SCITUATE PLANNING BOARD MINUTES November 12, 2020

Discussion on Site work related changes – Senior Center – 333 First Parish Road

Mr. Kirby reviewed site changes for the Senior Center at 333 First Parish Road. Mr. Kirby referenced a letter sent to the Planning Board that detailed the before and proposed changes to the site.

Attachment #1 – West Fence

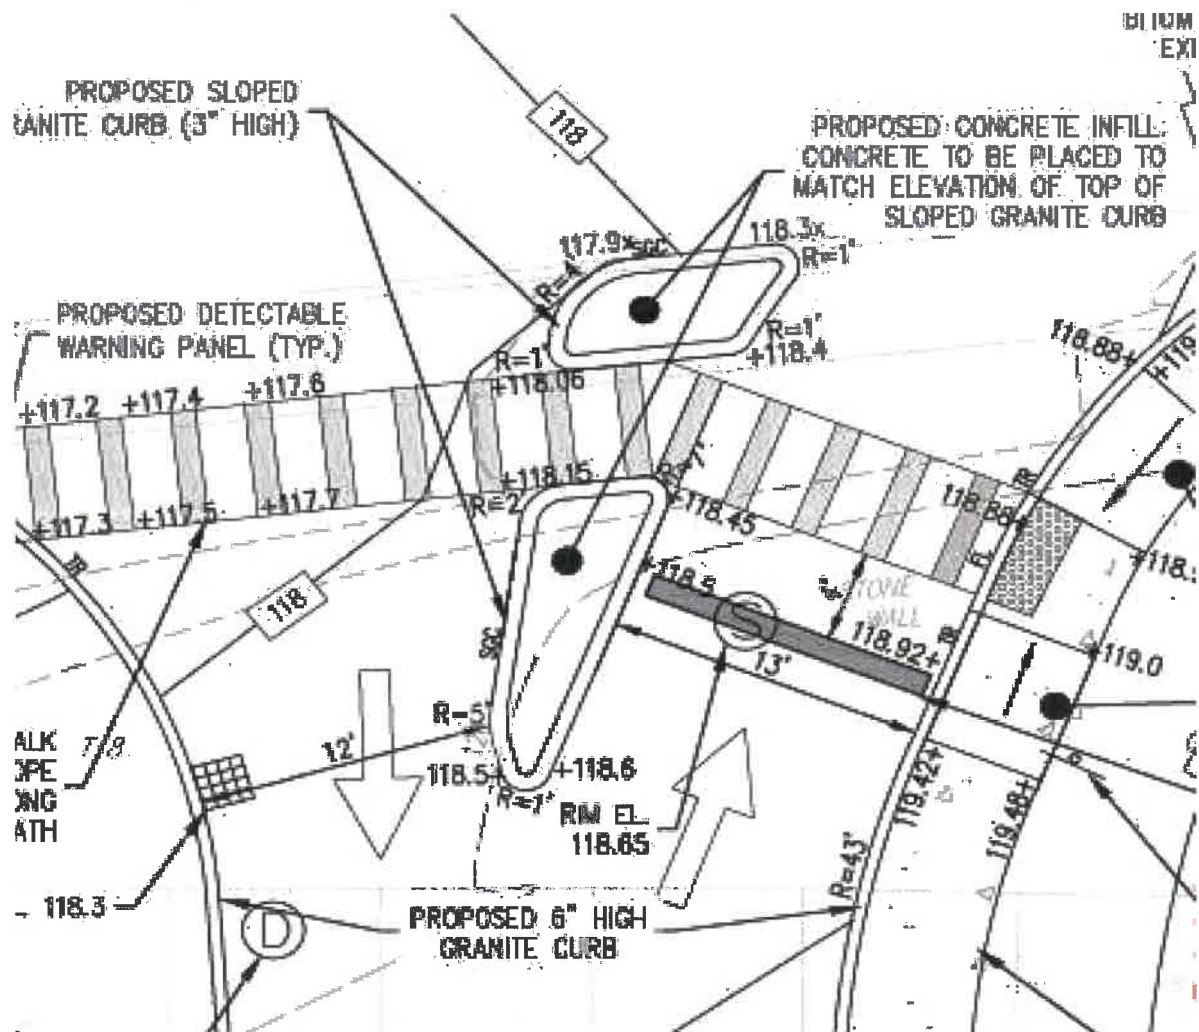
Item #1 – West Fence – site line issue with change of the new entry. Right lane exiting installed for safety at the site, working to maintain the safety of site by not creating a blockage to the site lines; fenced pulled back 4.5'. There was discussion on the plans for clarification; the crosswalk was revised for the right turn only, pushing exiting vehicles back approximately 6' creating an issue with the sight line making the right turn out.

Attachment #2 – Main Entry Island Curb

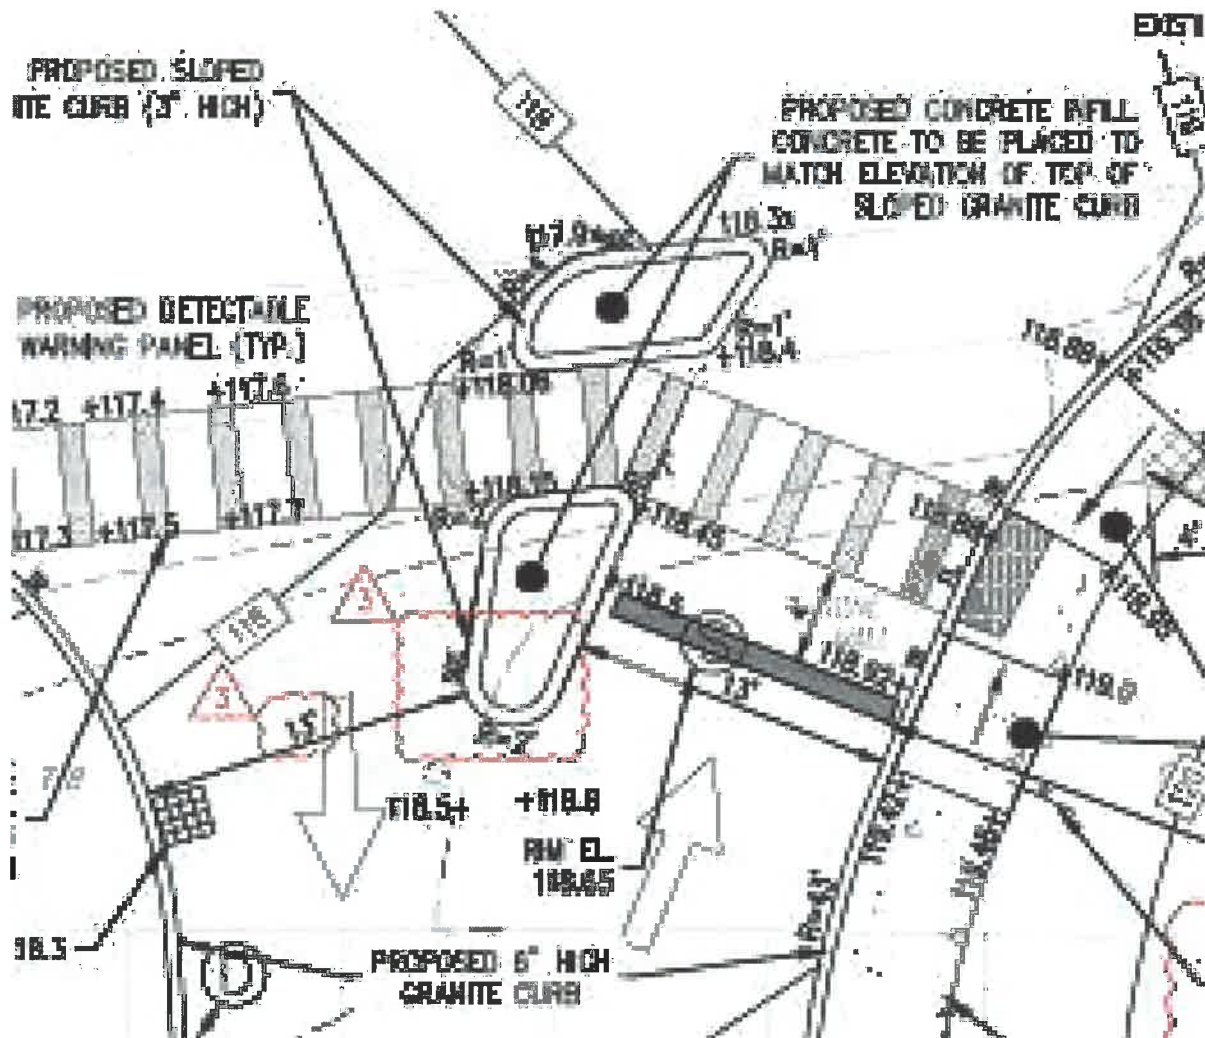
Item #2 – Radius change on south island curbing – made shorter to prevent vehicles from running over the curbing.

Attachment #3 – Tree at Gym

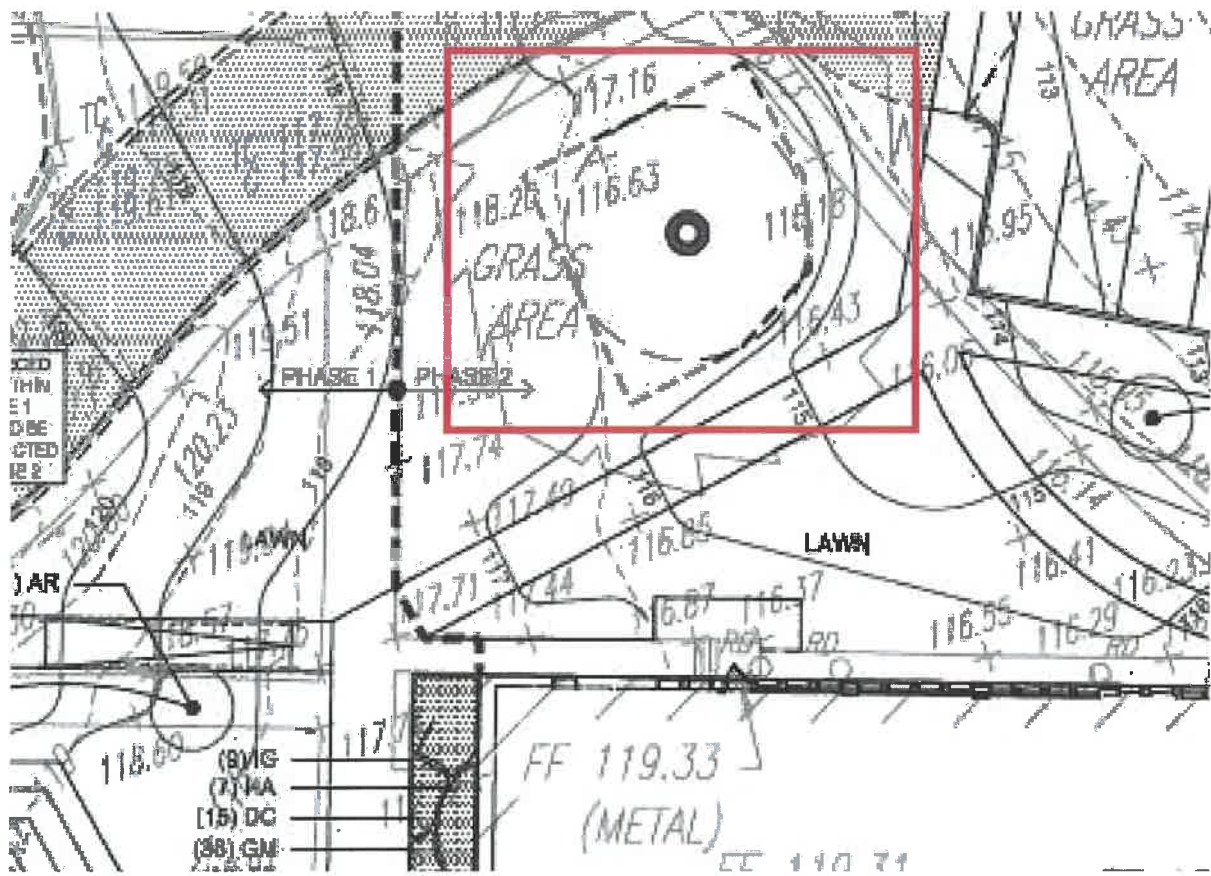
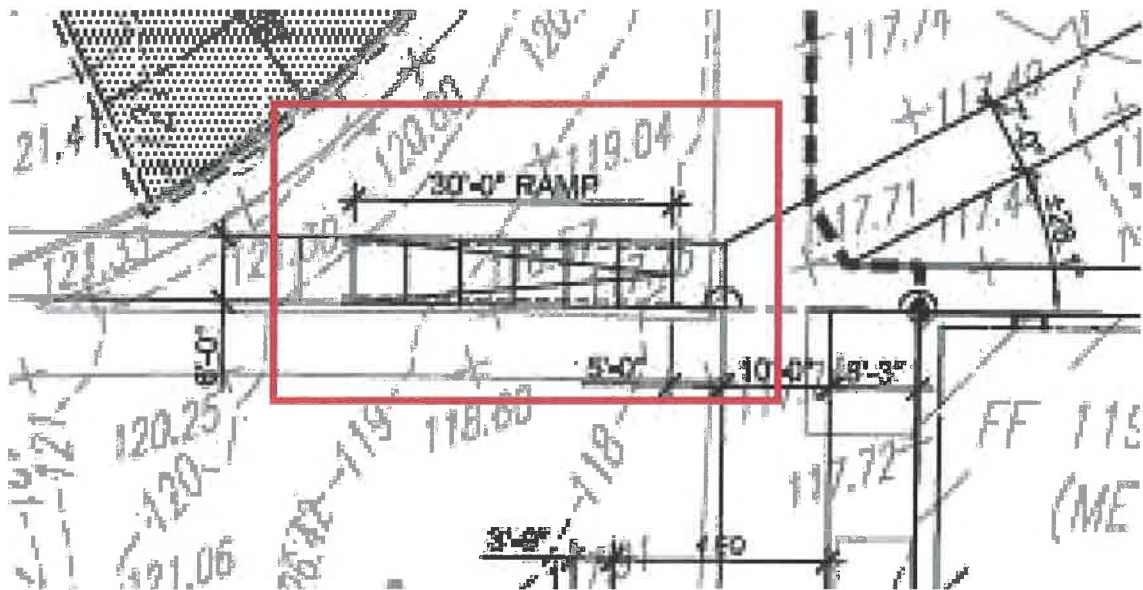
Item #3 – removal of a tree, tree deemed by the arborist that it need to be removed for safety concerns. The Board asked for a tree to be added in an appropriate place on the site.

Photographs 1 & 2: Tree #1 - 52" American Basswood (*Tilia americana*) that has extensive decay (approximately 30" deep) hollowing out the trunk.

Attachment #4 – B Wing Sidewalk East

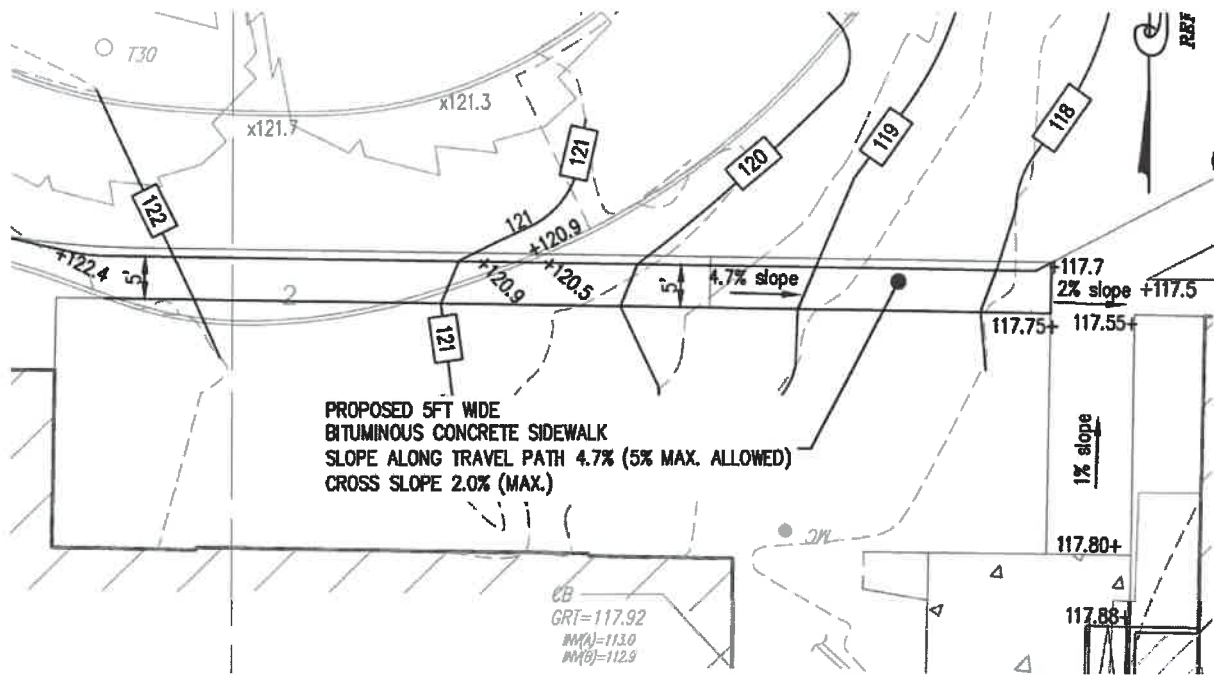
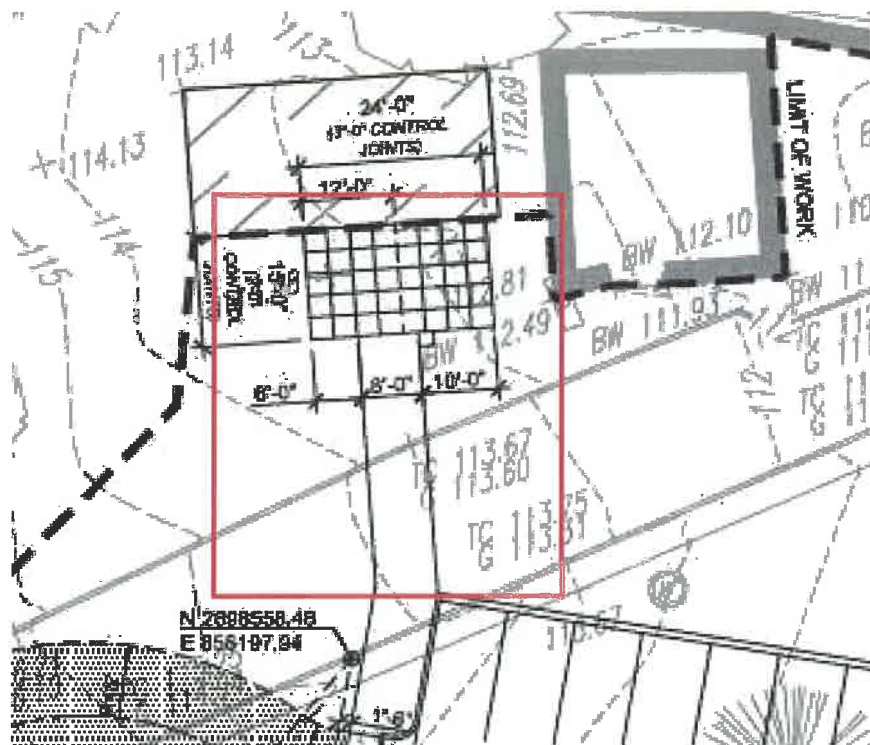
Item #4 – B Wing Side Walk – revised the grade to eliminate ramp and rails, now a bituminous concrete sidewalk; no change in function.

Attachment #5 – Carriage House Apron

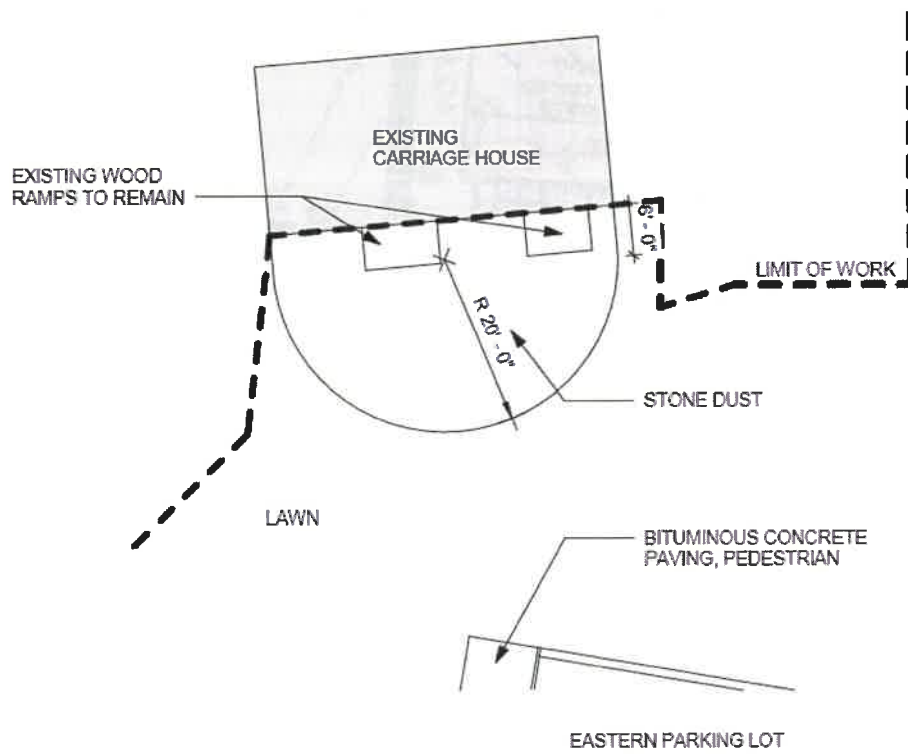
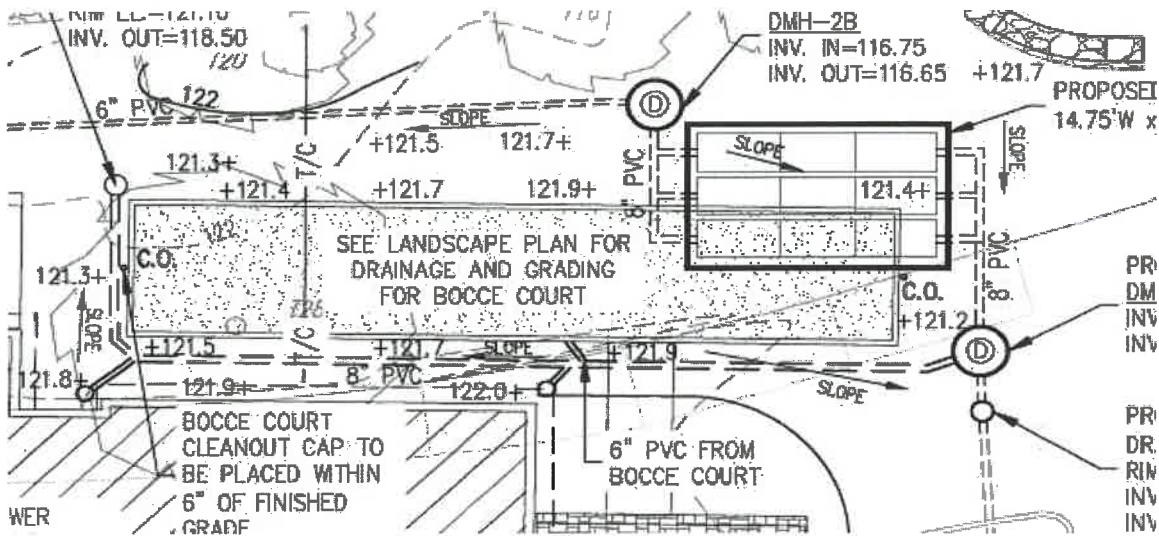
Item #5 – Revision to entrance to Carriage House – stone dust apron in half circle configuration, request of the Historical Society

Attachment #6 – Bocce Court

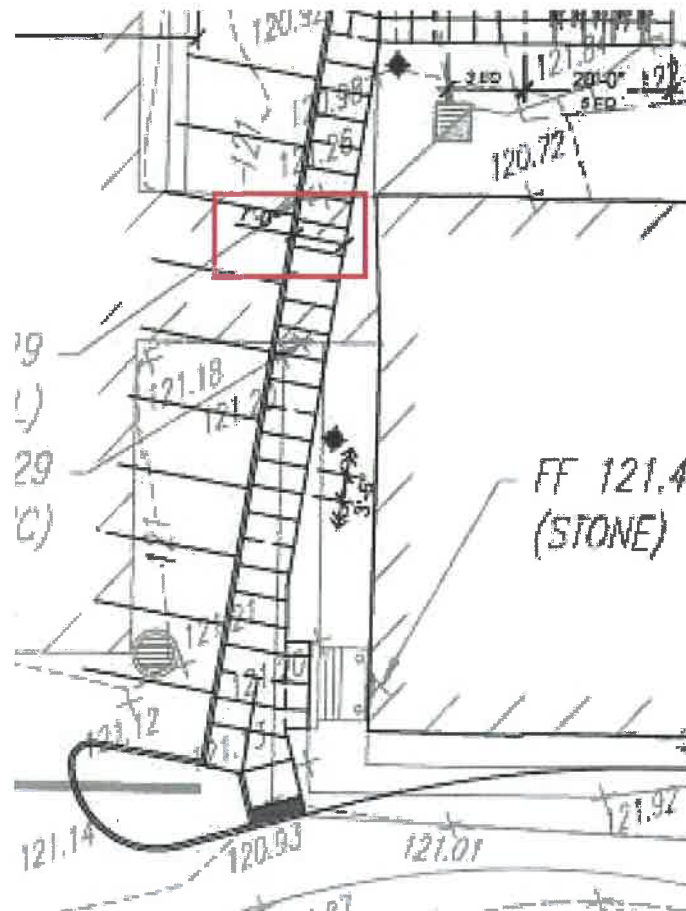
Item #6 – Drainage on Bocce Court - cleanouts moved from middle of the courts, will be outside the court and added underdrain below the bocce court material that ties into the original design.

Attachment #7 – B Wing Sidewalk West

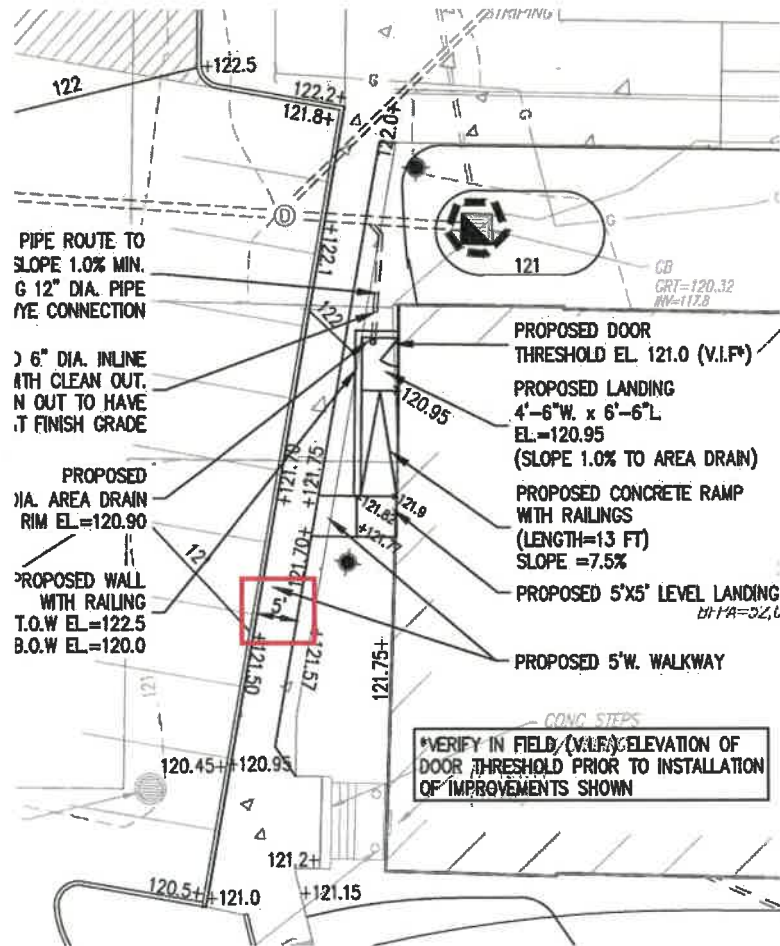
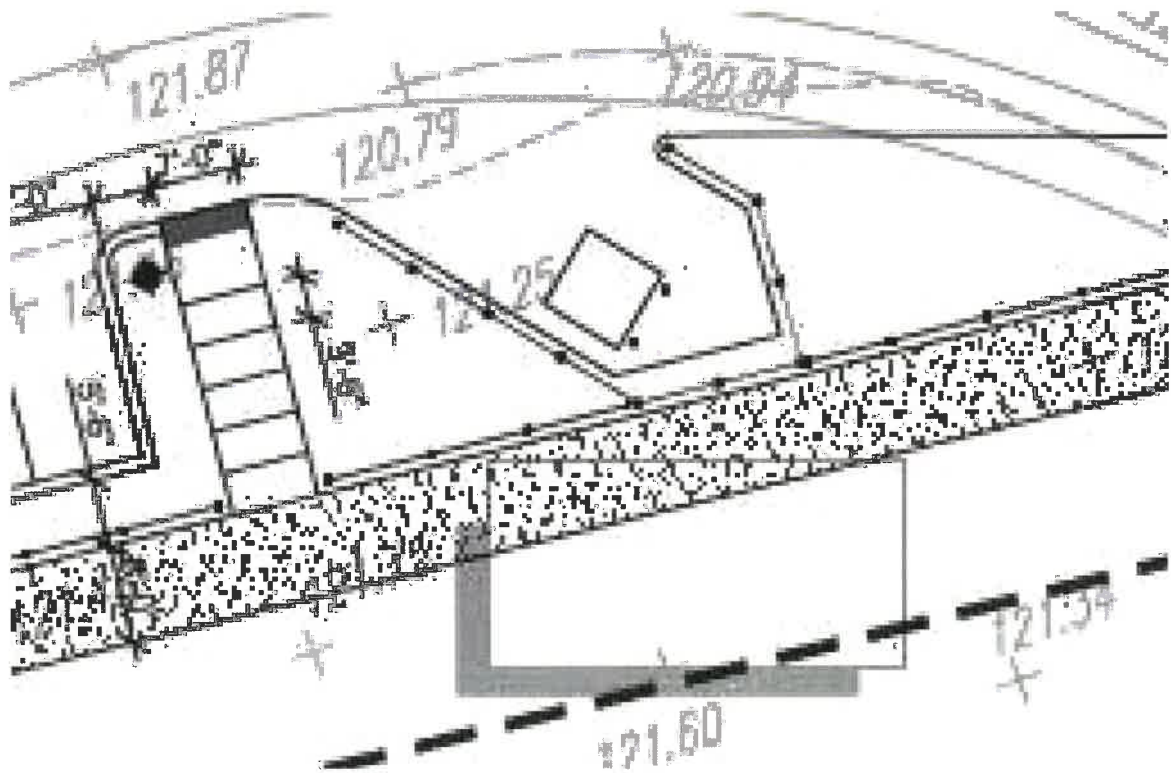
Item #7 – Sidewalk on B Wing - revision to make a 5' sidewalk to allow for potential concrete ramp for handicapped access in the future for Food Pantry.
